File No: D/2014/17/F
Our Ref: 2017/601713

SSD 5824 MOD 3 and MOD 4 – One Carrington Street Redevelopment

Modification 3

Modification 4

Typical bay with door inset - trachyte alteration detail

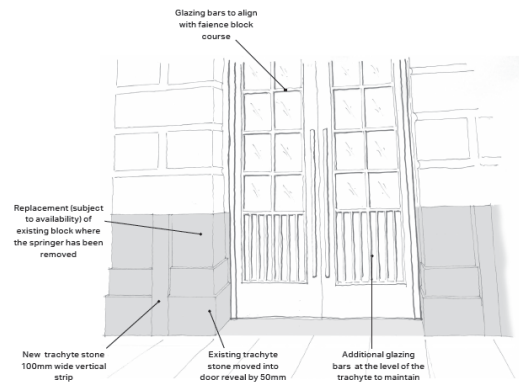
The proposed removal of three original steel framed windows with arched top panes, and trachyte voussoirs between, all dating from 1938 to create the new door openings into the lobby is not supported despite the details submitted on the 20th December 2016 below. The details, included below, have further convinced the City that the lowering of the three window openings would have a highly adverse impact upon the heritage significance of the building.

The removal of the steel windows assemblies and the demotion of the wedge shaped trachyte voussoirs that form the base of the building to form door openings will result in the loss of significant fabric and intricate architectural detailing; in addition to the loss of character and loss of character by eroding the strong base of the palazzo design of the building. These elements are key detail elements of the original Spain and Cosh design. The wedge shaped trachyte voussoirs of the base give emphasis to the voussoirs of the faience semicircular arches above and are architecturally mutually dependent. Further, the proportions of the proposed doors are overly vertical and are not representative of the proportions of the façade. The symmetry and balance of the façade is not restored as claimed by the Design Report. It is considered that the opposite results occurs, the façade at the lower levels of the building, becomes asymmetrical in its composition.

Internally, the fine window joinery including timber reveals and architraves will also be impacted upon. All joinery should be retained and conserved.

In conclusion we do not support the proposed lowering of the Carrington Street windows to form doors. The levels of the ground floor, both in Shell House and the

adjacent new link building, need to be reconsidered so that it is not necessary to extend the Carrington Street levels down to the ground. The new link building is the ideal location for accessible entry to the complex.
